## **ADDENDUM NO. 1**

**PROJECT NAME: *Grand Ridge Fire Station***

**PROJECT NUMBER: *FLORIDA COMMERCE: CDBG MT147***  
***DHM PROJECT NUMBER: GRD22MT***

**GRAND RIDGE FIRE DEPARTMENT  
ARCHITECTURAL ADDENDUM  
November 12, 2025**

# A-1.0

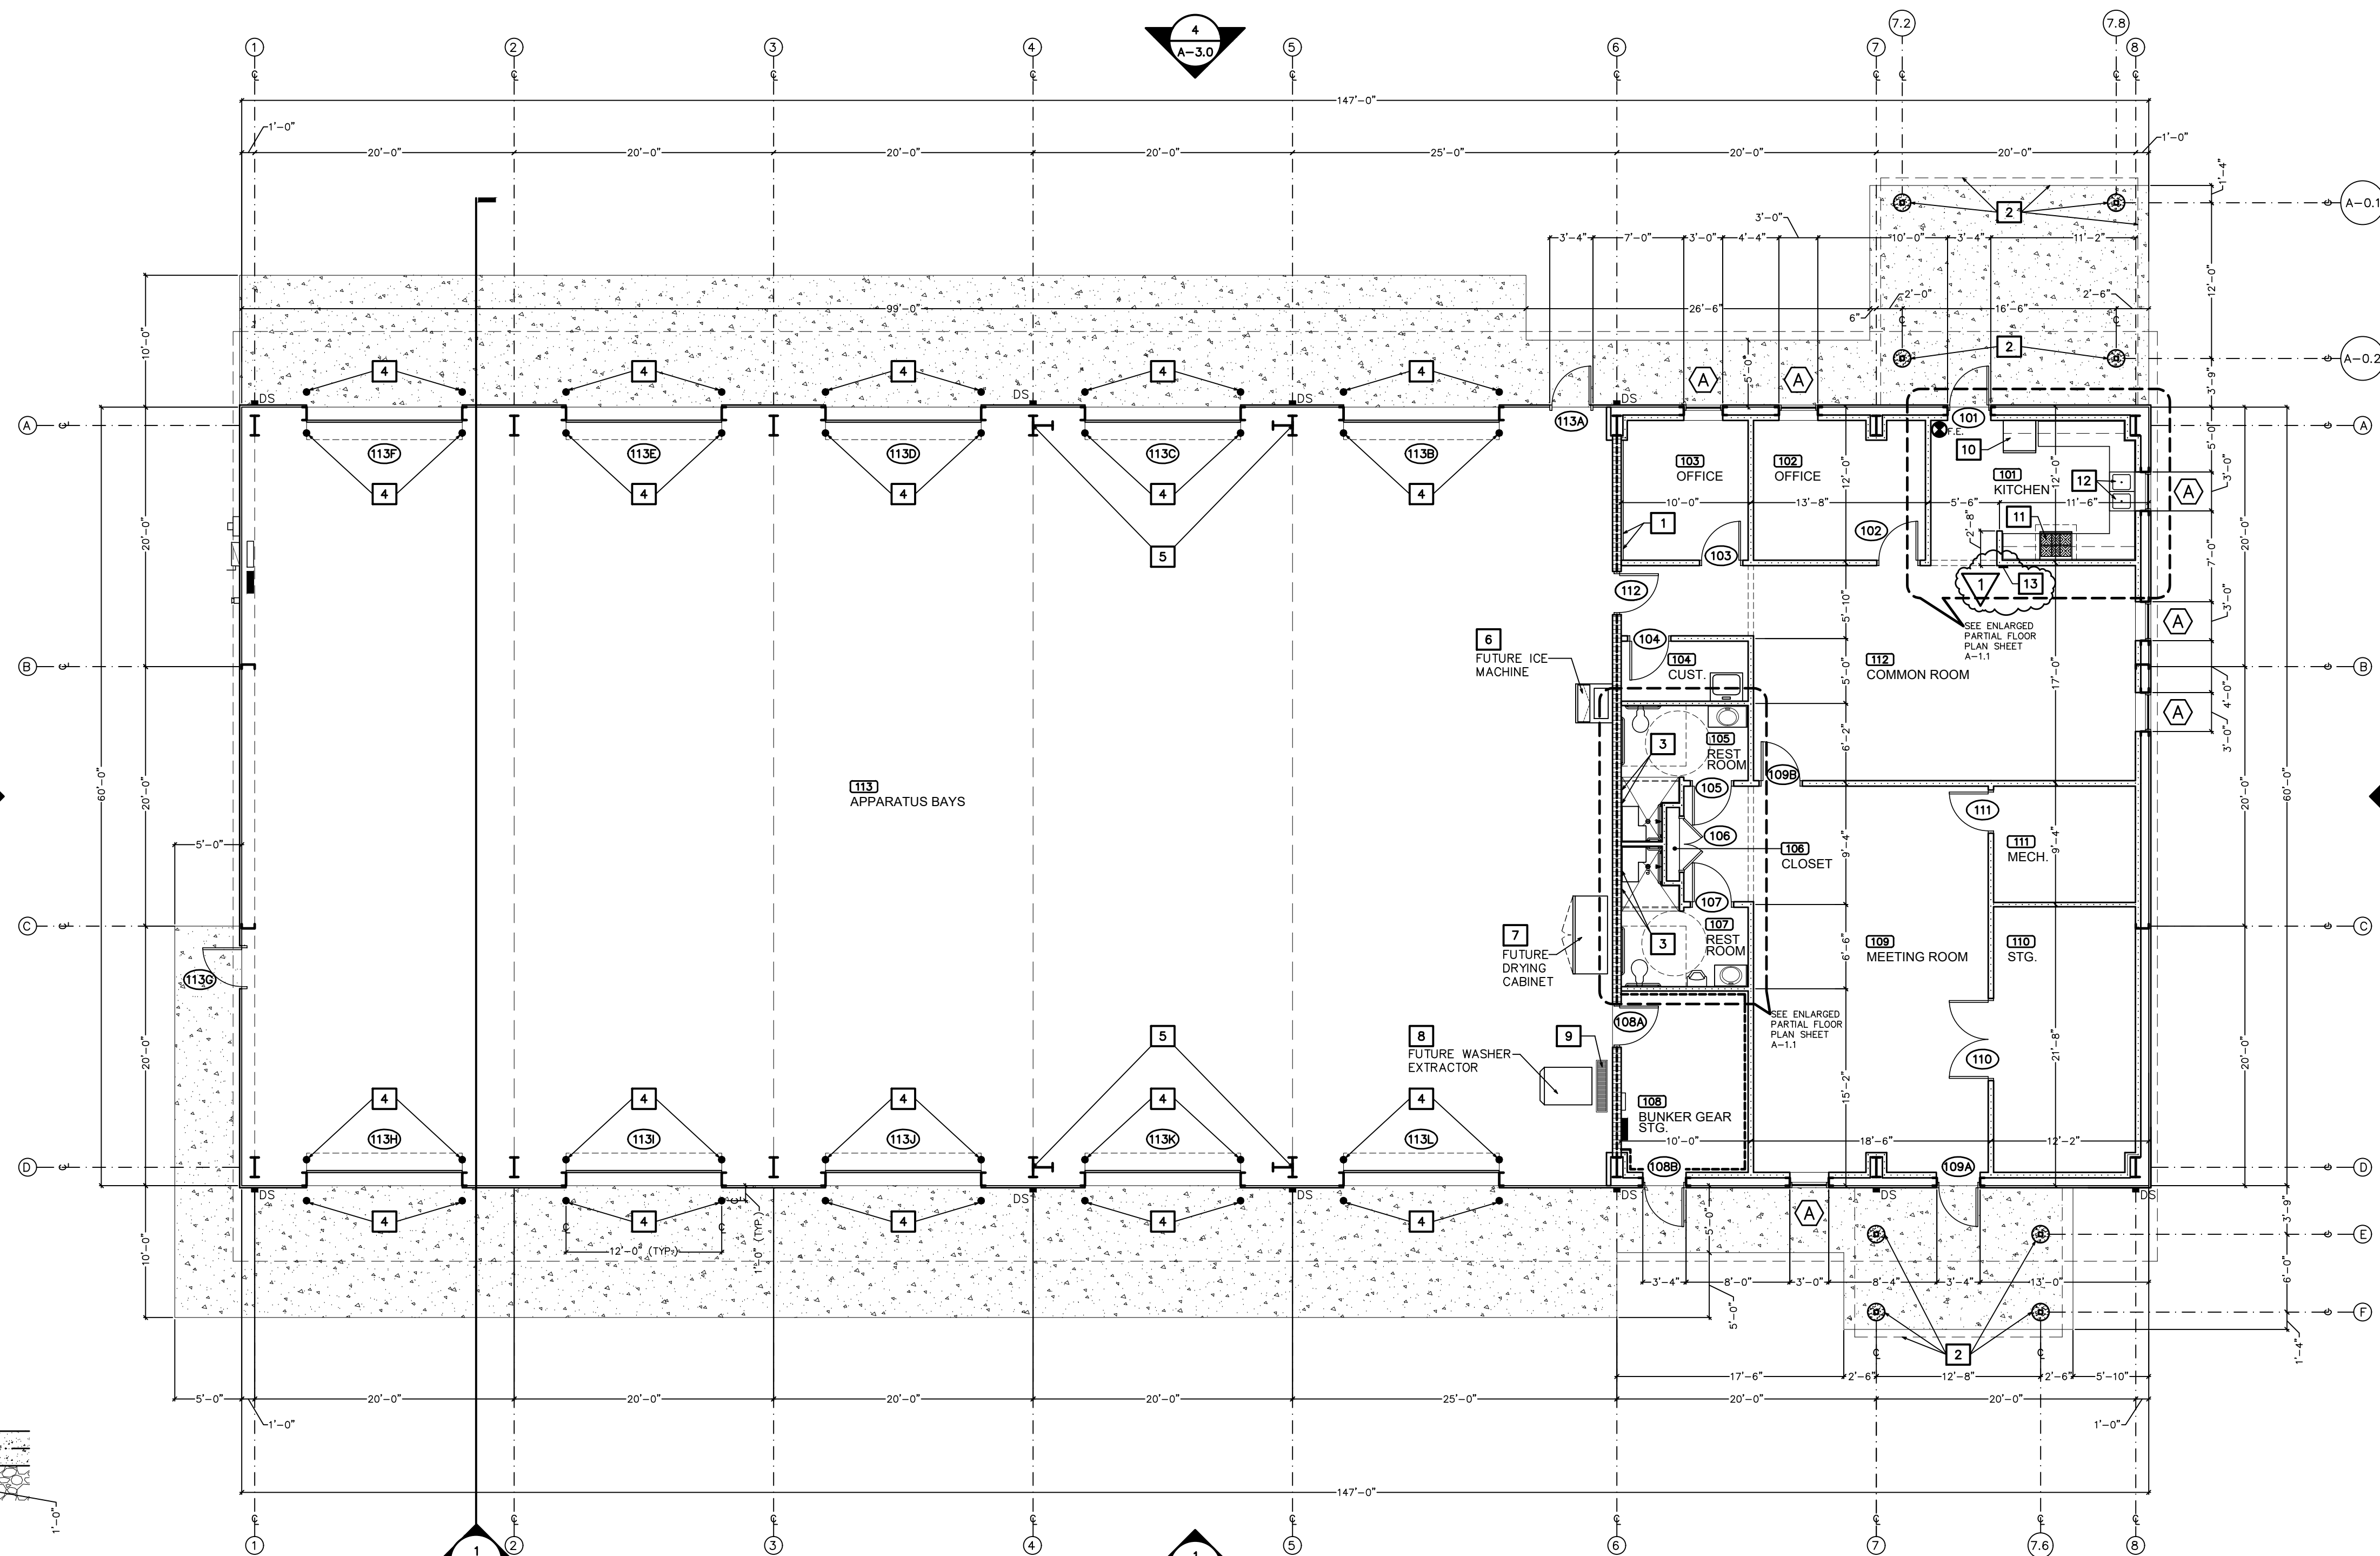
| <b>Item 1:</b><br>11-12-2025 | <b>Drawings, Sheets A-1.0, A-1.1 and A-2.0, See Revised Sheets A-1.0, A-1.1 and A-2.0, included with this addendum</b><br><br><b>ADD</b> – Room sign for Kitchen 101 at east side of cased opening between Kitchen 101 and Common Room 112                                                    |

- INDICATES LOCATION OF FUTURE (2) COMPART. S.S. SINK SEE MECH. DRAWINGS FOR UTILITIES
- PROVIDE & INSTALL ROOM SIGN FOR KITCHEN 101

SHEET No.  
A-2.0

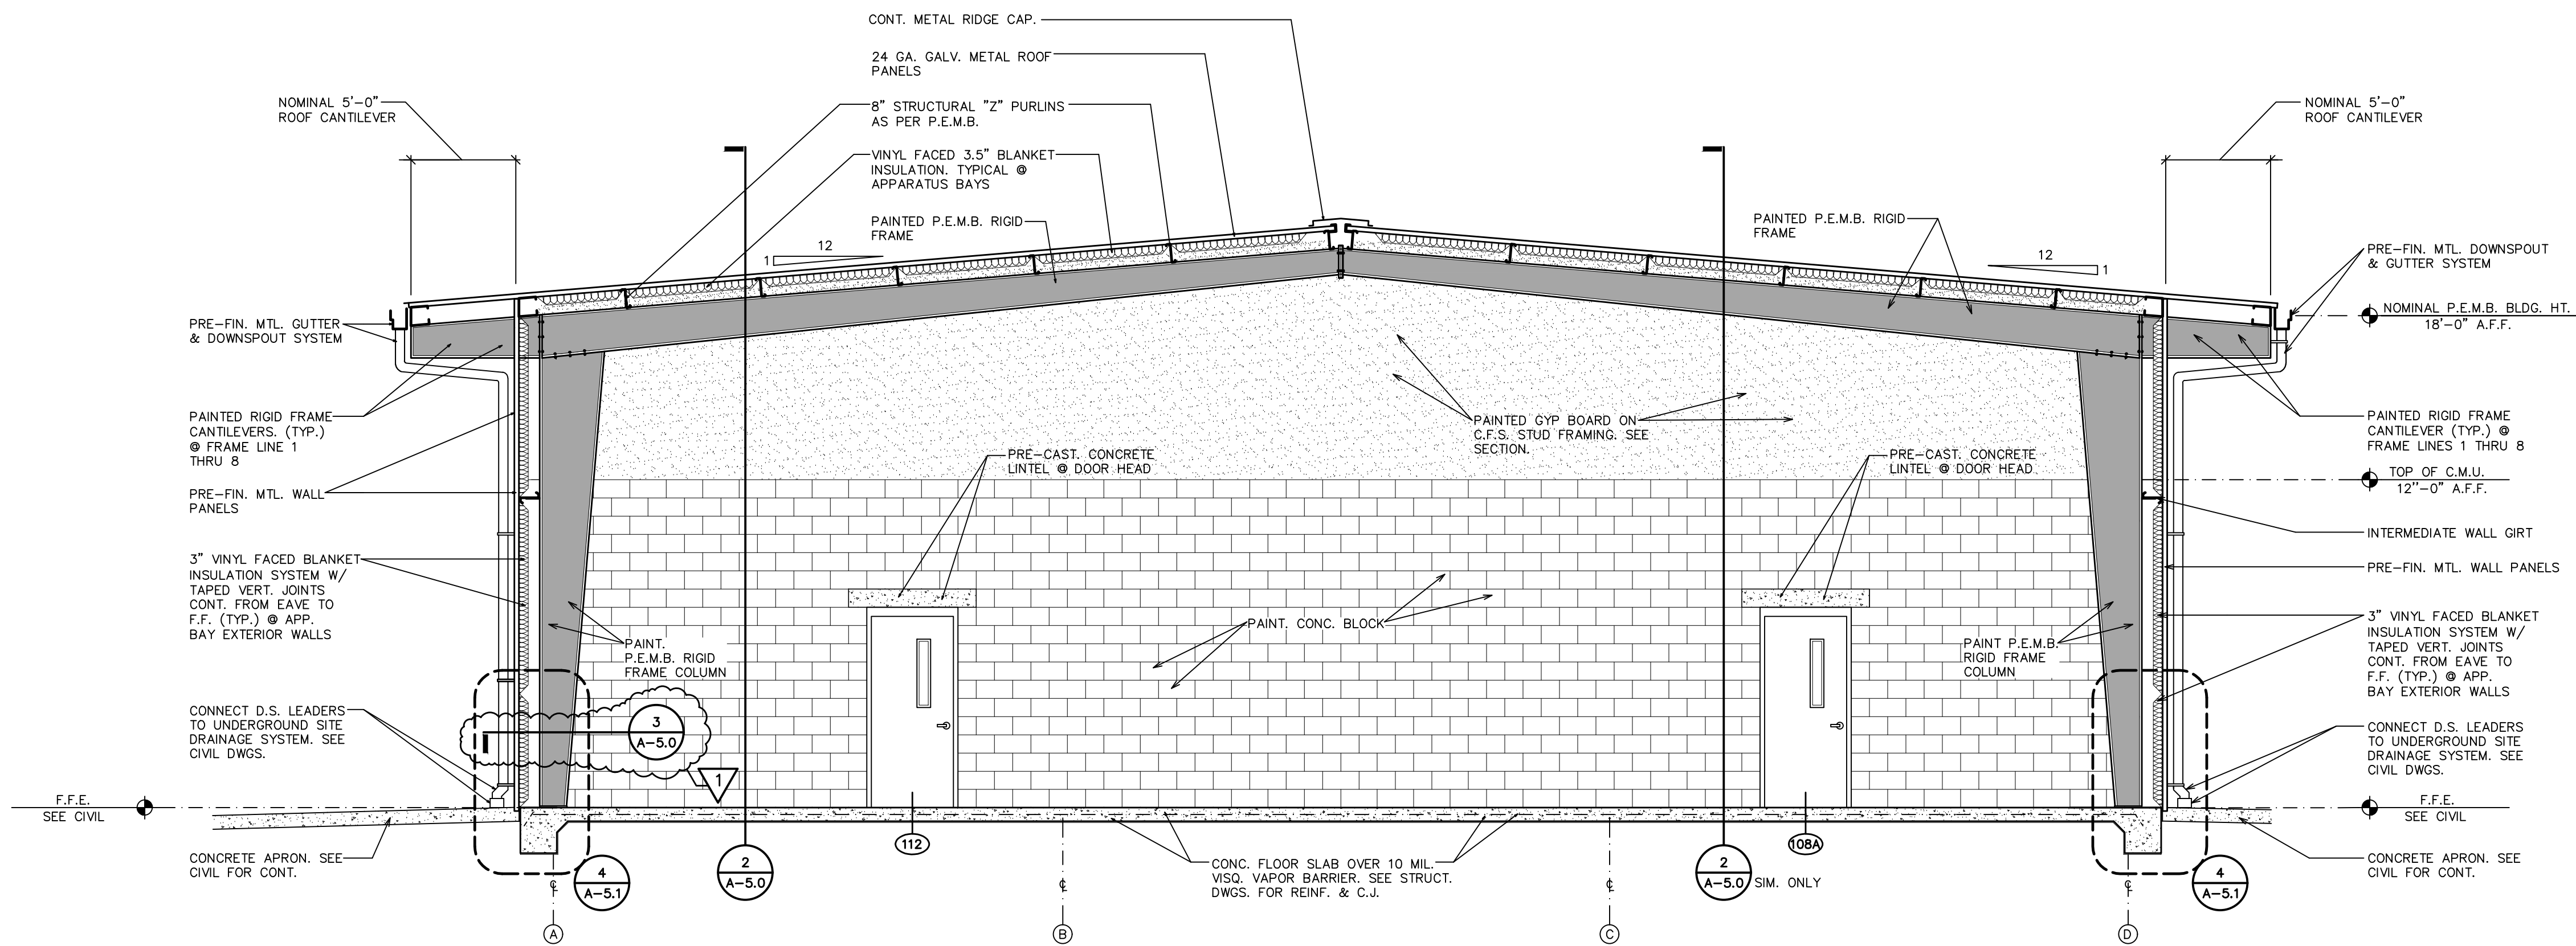
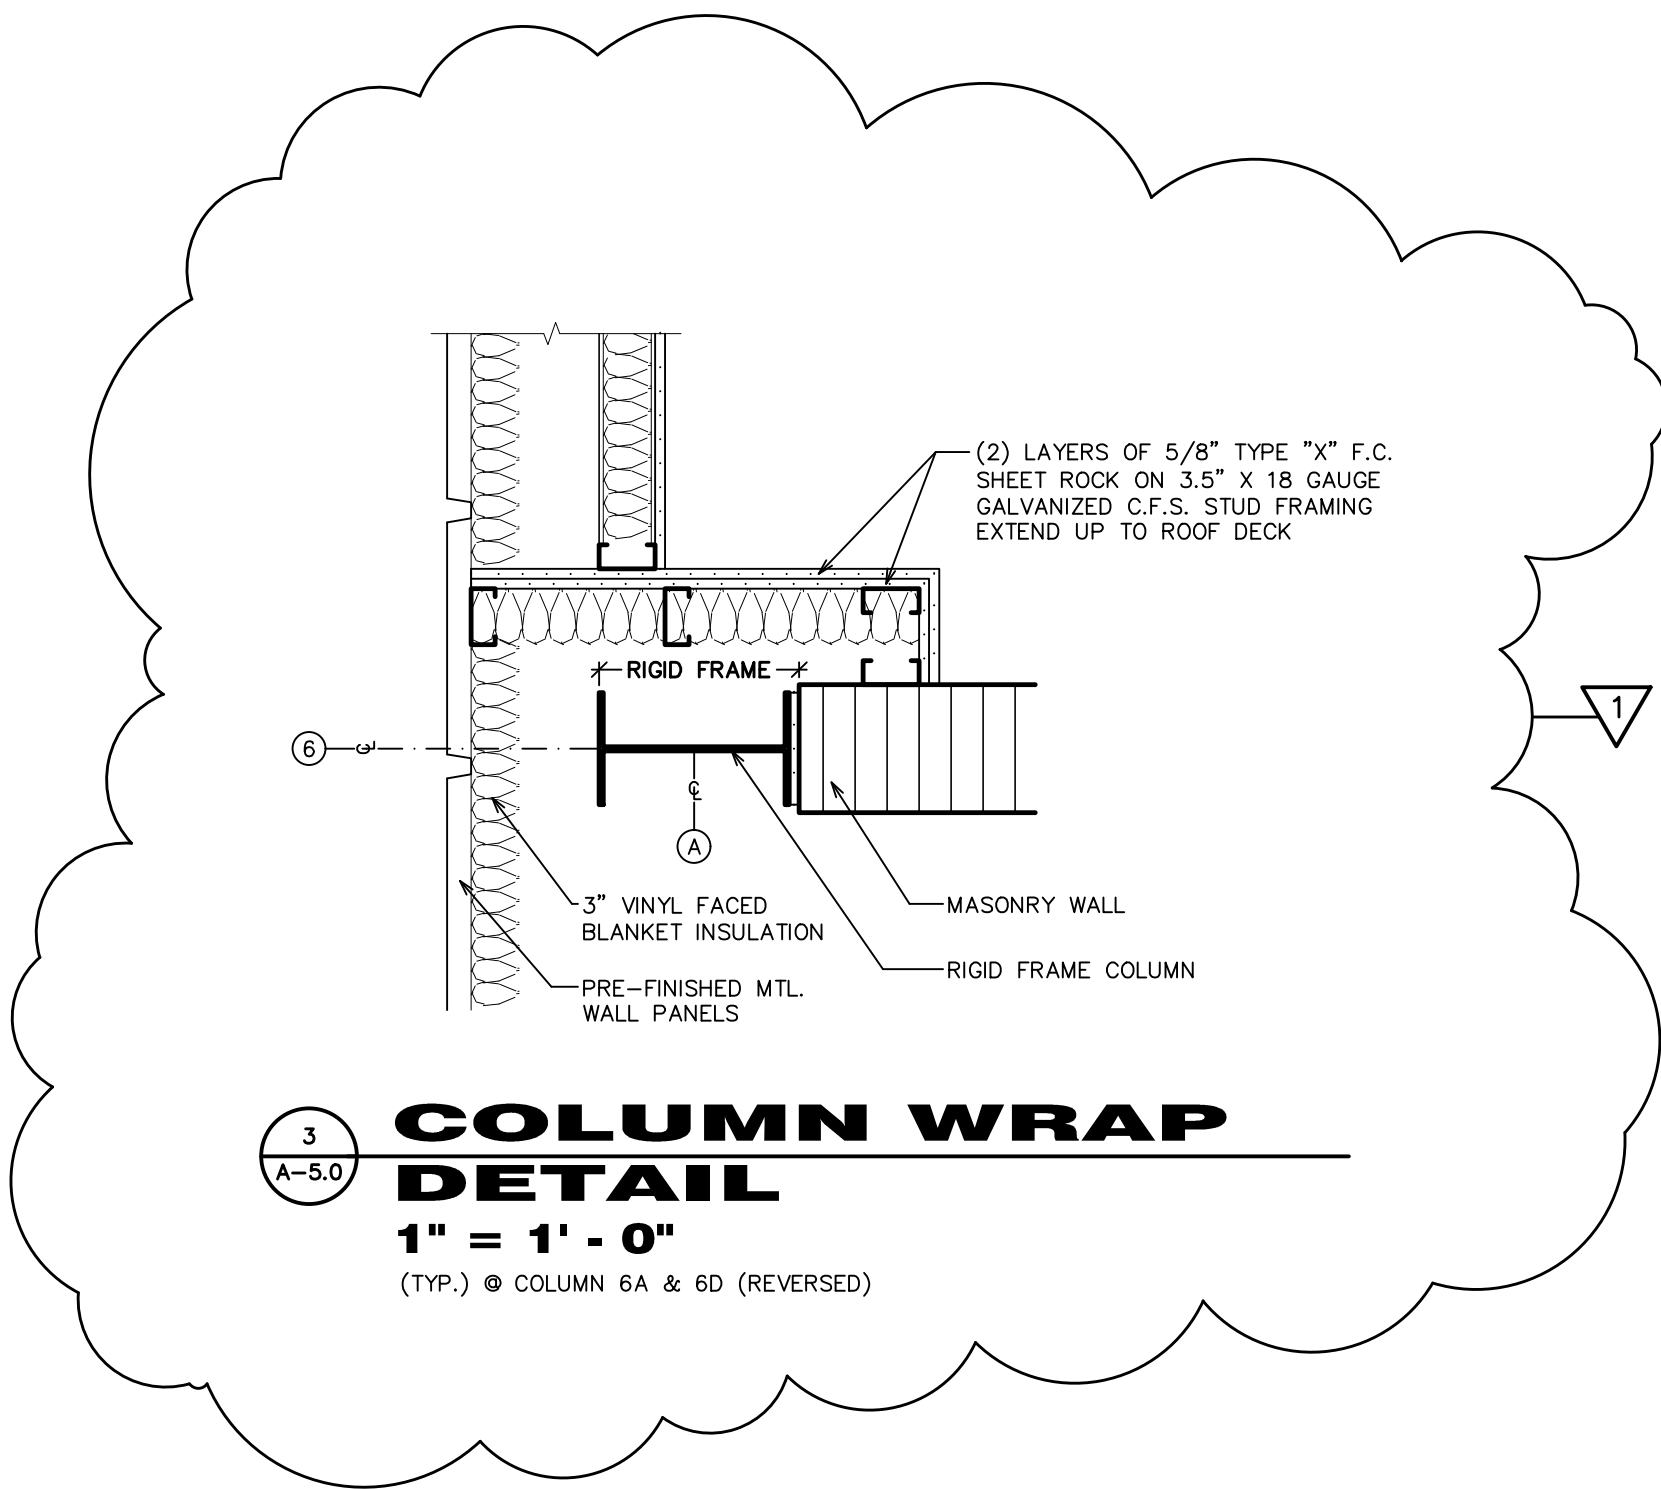
| <b>Item 2:</b><br>11-12-2025 | <b>Drawings, Sheet A-2.0, Door Schedule, See Revised Sheet A-2.0 Door Scheduled, included with this addendum</b><br><br><b>ADD-</b> Room numbers to Room Signage at doors 102, 103, 104, 105, 106, 107, 108, 109B, 110, 111, and 112                                                          |

NOTE!  
AT ALL INDICATED DOOR SIGNS TO INCLUDE  
ROOM NUMBERS IN ADDITION TO ROOM NAMES
